Final Product Change Notification

PCN number 2026080001

PCN 2026080001	Final Qualification Report: <i>Qualify SBD products to Xinshun and Takcheong</i>

*Qualify Wafer fab/Xinshun
and Assembly factory/Takcheong
as Second Source for SBD products*

1) Package Structure:

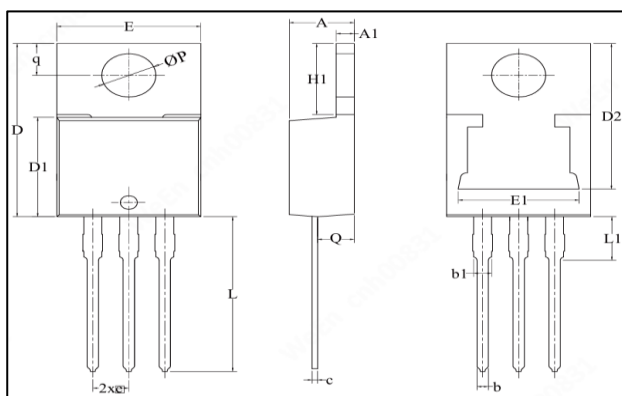
Site	E-tech	Tak Cheong	Remark
TO220			Different heatsink appearance
TO263			Different heatsink appearance

Remark: The heatsink design shows cosmetic difference between the two assembly sites.

7. Package Dimension Comparison

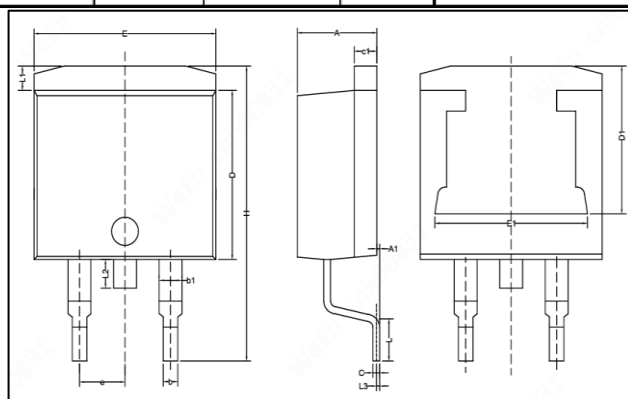
Remark: There are minor dimensional differences between E-tech and Tak Cheong's package outline drawings (POD).

9.1 Tube Size

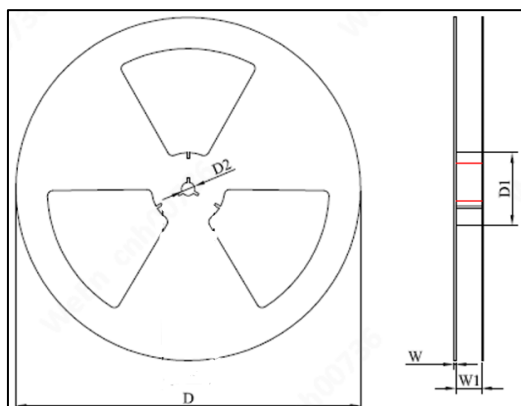
50 units in 1 Tube, 20 Tubes in 1 PQ, total 1000 units in 1 PQ Box at E-tech and TakCheong.

9.2 Carrier & Reel Size

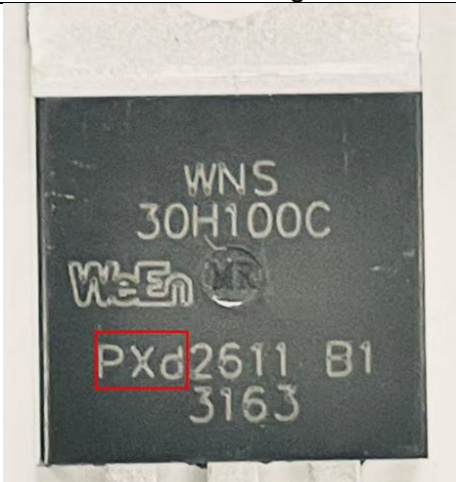
Remark: No change on key dimensions.
